20 September 2021

Ref: 201408.2L

REV2021/0034 (DA2020/0442) – 231 Whale Beach Road, Whale Beach – Objection on behalf of 233 Whale Beach Road

Figure 1: North Elevation - Original DA (top) and Review Proposal (bottom)
 Source: Plans prepared by Richard Cole Architecture

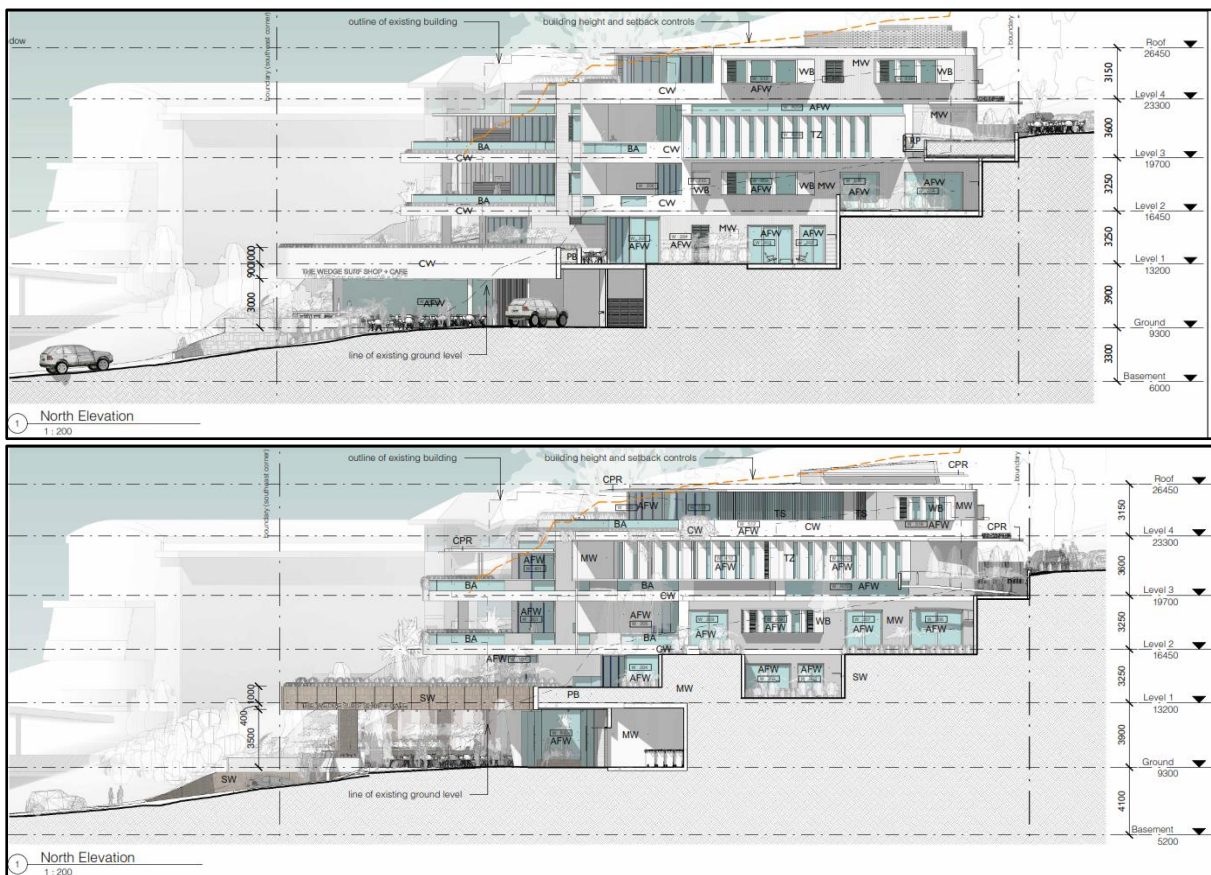
Comparison of the original DA and the Review proposal plans (see **Figure 1** below) indicate that, while additional side setbacks are now proposed, the built form is otherwise very similar to the original with similar stepping profile and bulk and scale to the side elevations.

The proposed built form is still considered to dominate the landform and landscape in a manner inconsistent with the Desired Future Character of the Locality which requires that *development on slopes will be stepped down or along the slope to integrate with the landform and landscape, and minimise site disturbance*. Virtually no change has been made to the original proposal in terms of stepping down the slope as shown in **Figure 1** above.

The bulk and scale of the proposed north elevation adjacent to our client's property is excessive and will have an adverse impact on our clients' property and the wider public domain. While the Review proposal meets the DCP side setback requirements, it still involves a breach of the side setback requirement for residential accommodation under SEPP 65 and the ADG which requires a minimum side setback of 6m (a total of 12m separation across boundaries). While this setback applies only to residential accommodation, the provision of greater setbacks to the proposed development would allow for more site landscaping and reduce the overall built form.
